Staff Report – Planning & Zoning Item

Date: November 20, 2017
Case No.: Z-17-16
Request: PD MF (apartments) to PD MF (townhomes)
Applicant: Dana Tatum

Z-17-16 Hold a public hearing and consider a zoning change from Planned Development Multiple Family for apartments to Planned Development Multiple Family for townhomes on a 6.285 acre tract of land, located on the northwest side of East Loop 121, just southwest of Holland Road.

Date Drawn: November 12, 2017
Drawing Scale: As Noted

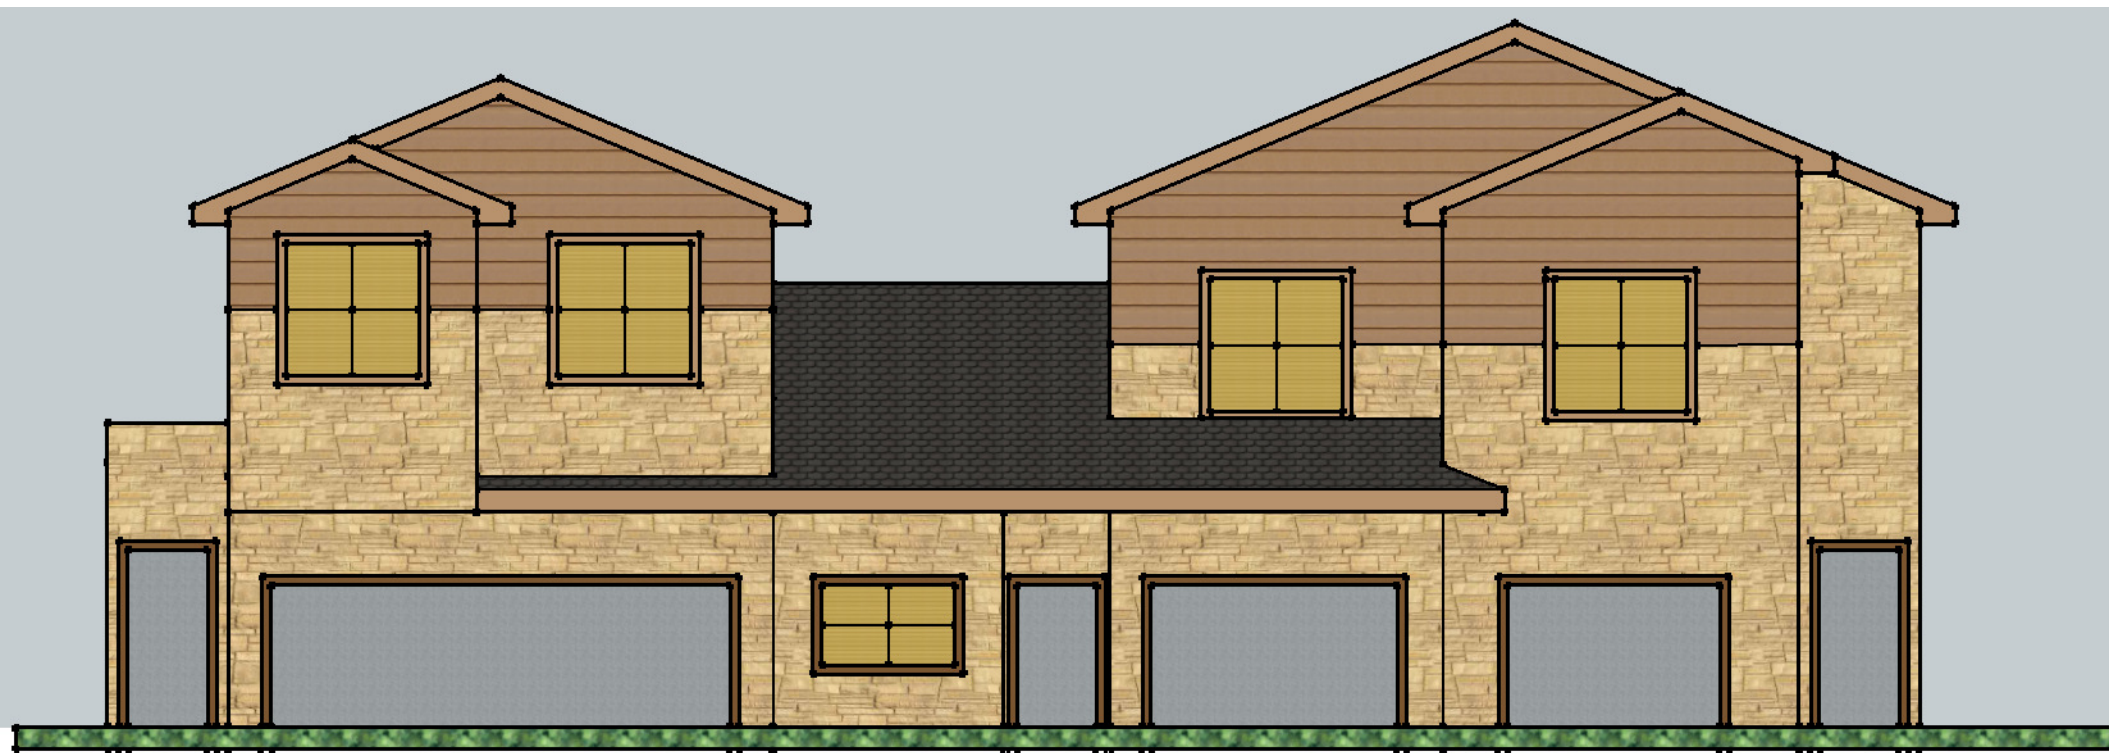
The applicant is proposing to construct a townhome community with 9 cluster modules containing a total of 55 dwelling units. The cluster modules range from 2 units to 12 dwelling units; however, the cluster modules do not exceed 300 feet in length. The Planned Development proposal would allow for a maximum of 12 dwelling units in a cluster module. The lot sizes in this development vary, with the minimum lot size at 25 feet in width and 90 in depth, a total of 2,250 square feet in area. The proposed lots comply with the lot width and depth requirements; however, some lots are smaller than the required lot area of 2,700 square feet. The applicant is requesting the Planned Development proposal allow for some of the lots to be 2,250 square feet in area. Since the applicant is proposing a zoning change to allow for townhomes instead of the previous request for apartments, the overall density is much less than previously approved, an estimate of 113 dwelling units; therefore, these requests appear to be reasonable. All of the dwelling units will consist of 90% masonry, in accordance with the Design Standards.

PROPOSED PLAT:
Final Plat
Three Creeks Phase IV
38.44 Acres

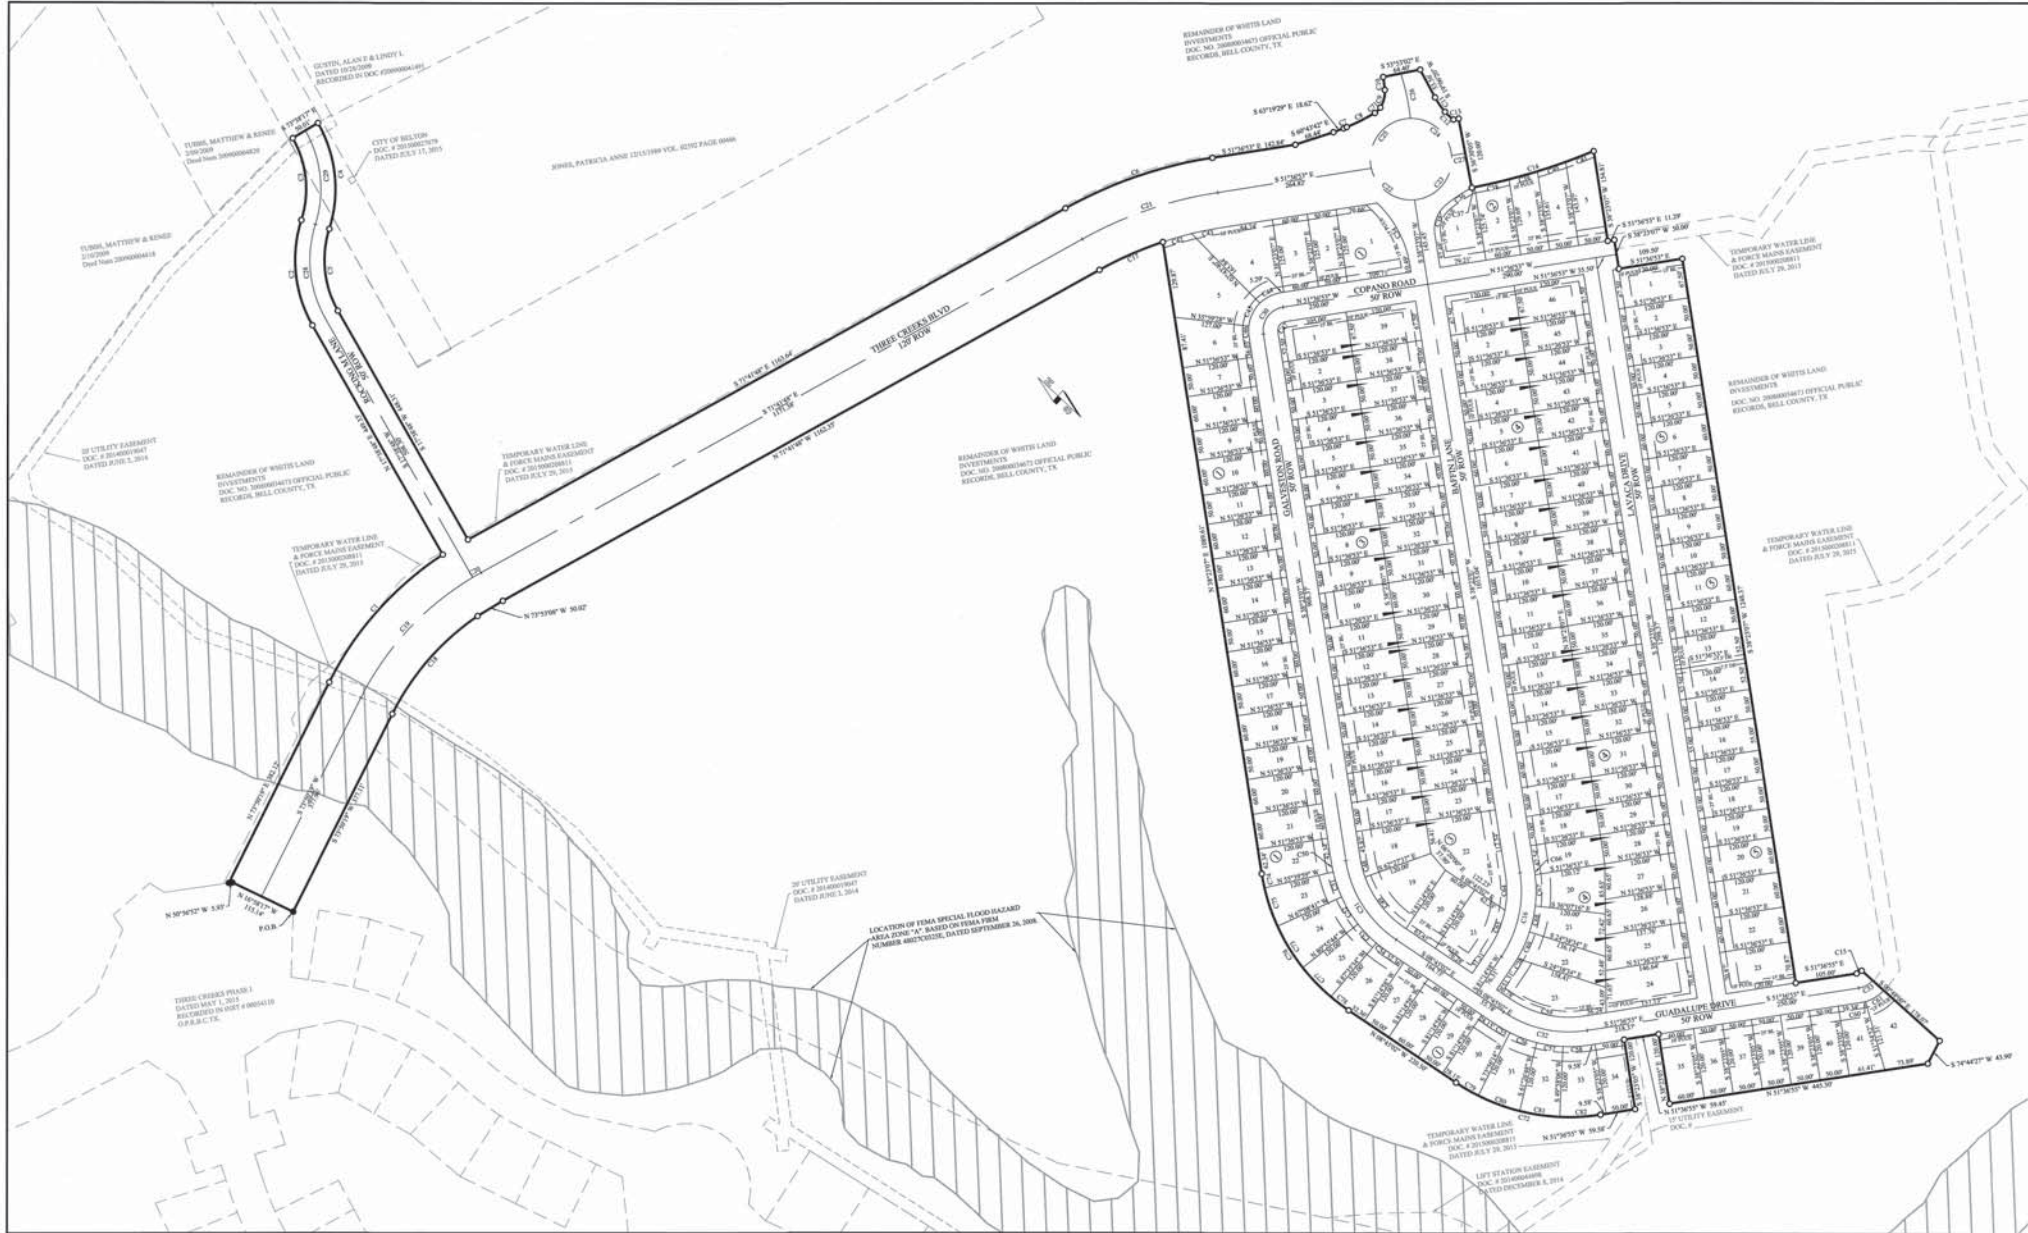
1. Please contact us to schedule a meeting to discuss comments.
2. Please confirm the block length of Lavaca Drive, Baffin Lane, and Galveston Road. The block lengths exceed 1,200 linear feet. Please revise.
3. Lot 21, Block 3 is a corner lot shown with a 25' street side yard setback. A 15' street side yard setback is permitted on corner lots with a front-entry garage. If a revision is desired, please adjust prior to P&ZC and Council consideration.

- **204.2- Dedication**- Please provide a revised copy of the dedication by separate instrument, as the proposed acreage has changed from preliminary plat submittal. Include field notes.

- **203.5- Street Names**- 911 approval of the proposed street names is required.
- Bell County prefers eliminating the street name change between Galveston & Guadalupe at Baffin Lane. It should be one street name throughout.

- **204.11- Restrictions**- Provide a copy of any proposed restrictions or covenants for phase IV.
- **204.15- Acreage & Length**- An acreage & length statement for the proposed streets & right-of-way's is required on the plat. Please breakdown the statement by street.

- **303- Design standards**- the proposed centerline radius for curves C28 & C29 along Rocking M Lane do not meet the county's minimum speed designs for local or collector roads. Please verify that they meet City of Belton requirements.
